Re: Review of the UMETCO Minerals Corporation's (Umetco's) ACL Application, TFN 3 1/258

WDEQ/LQD Technical Review Comments
Application for Alternate Concentrations Limits
Umetco - TFN 3 1/258 - April 2000

TO: Mark Moxley, District II Supervisor
FROM: Roberta N. Hoy, Geohydrologist *RNH*
DATE: April 10, 2000
RE: Review of Umetco ACL Application - TFN 3 1/258

FIGURE 3
GENERALIZED
HYDROGEOLOGIC CROSS-SECTION
UMETCO GAS HILLS TAILINGS

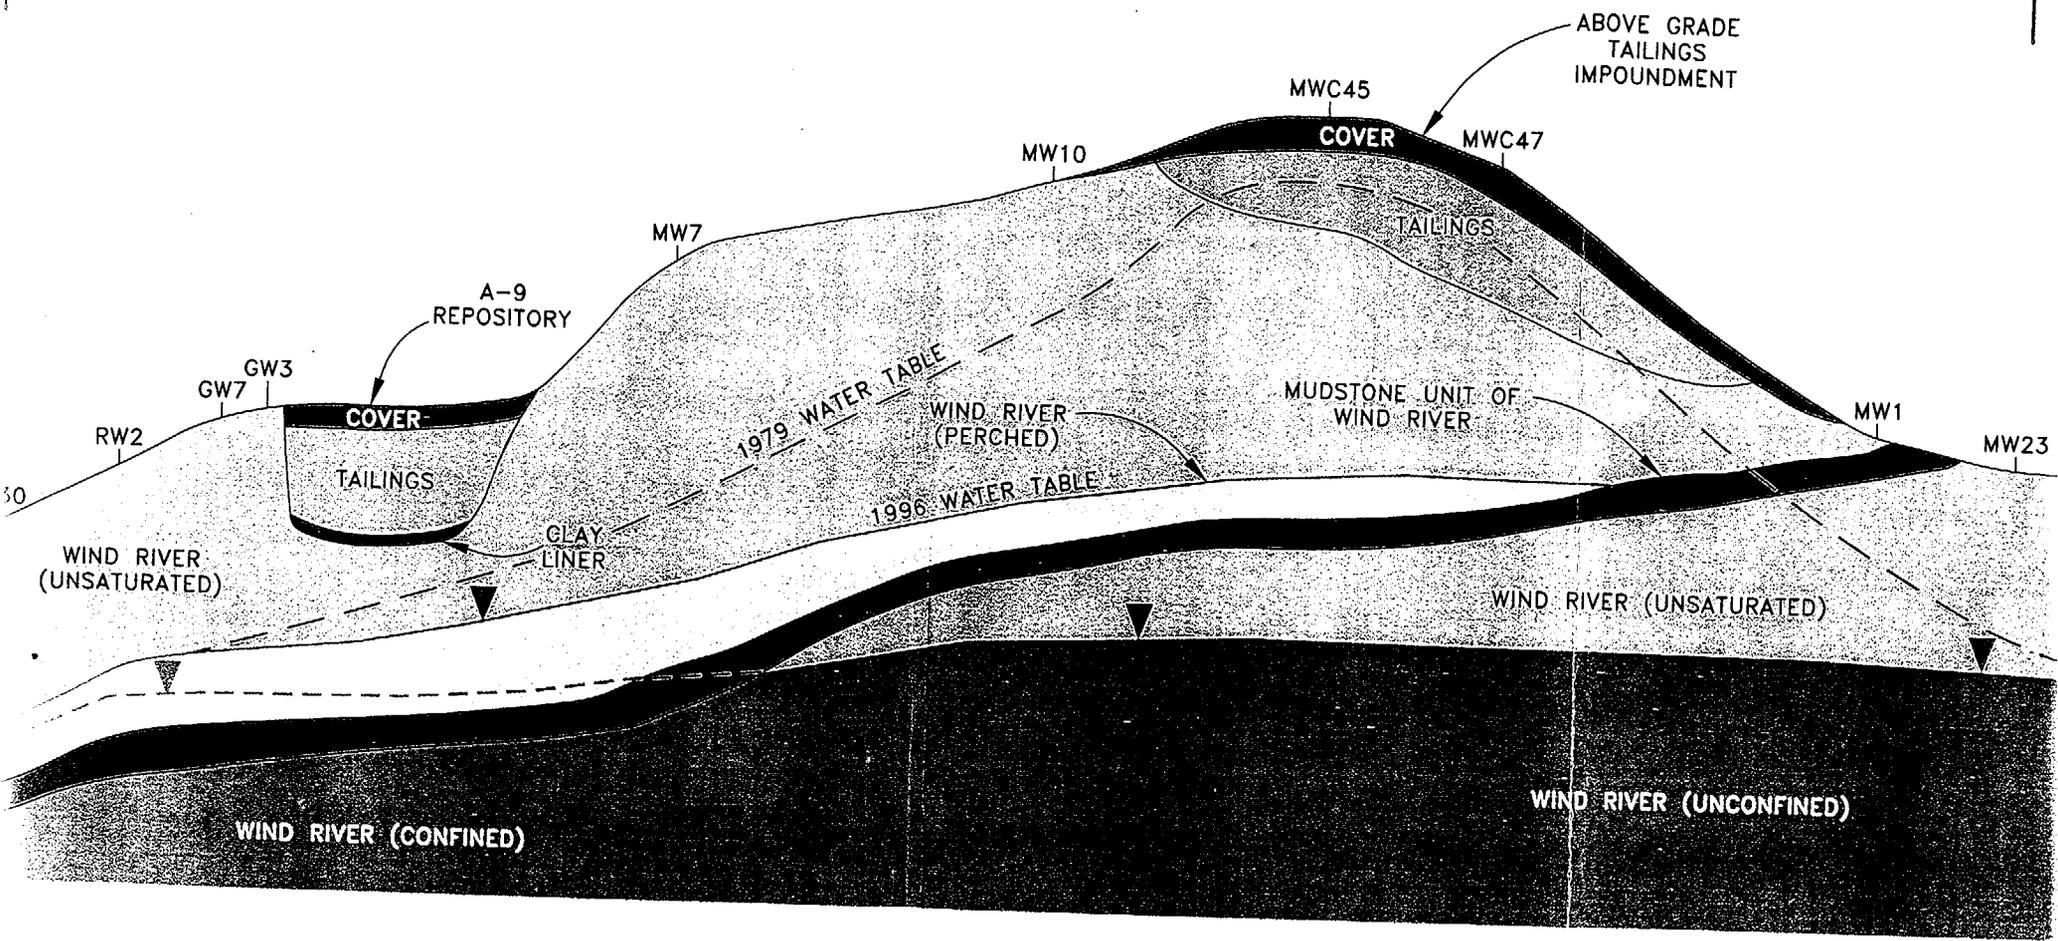
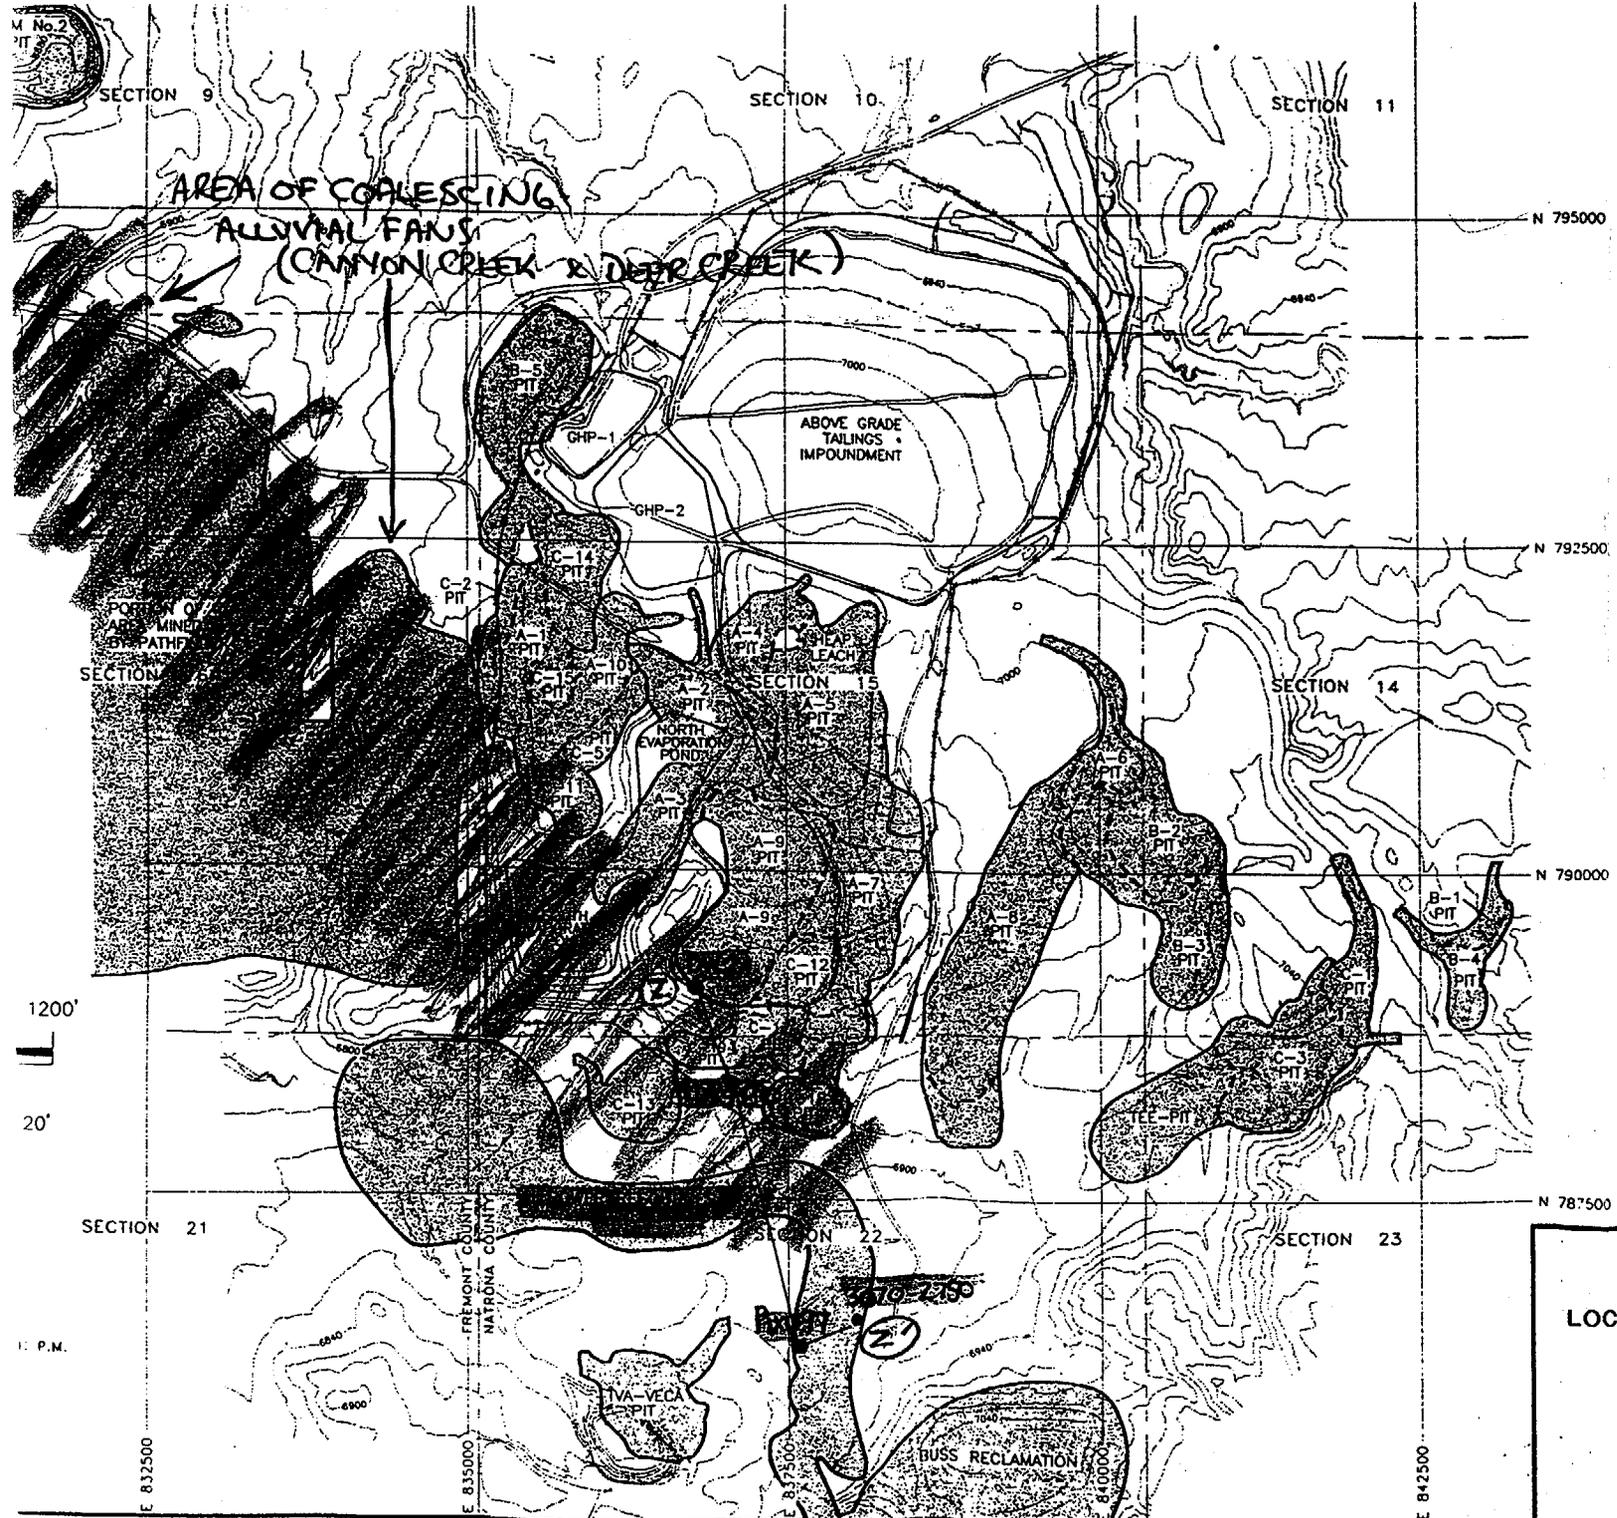
unconfined. Depending on ground water occurrence relative to the mudstone layer, the Lower Wind River Aquifer may be confined or unconfined. Figure 3 is a generalized north-south hydrogeologic cross-section through the Umetco site.
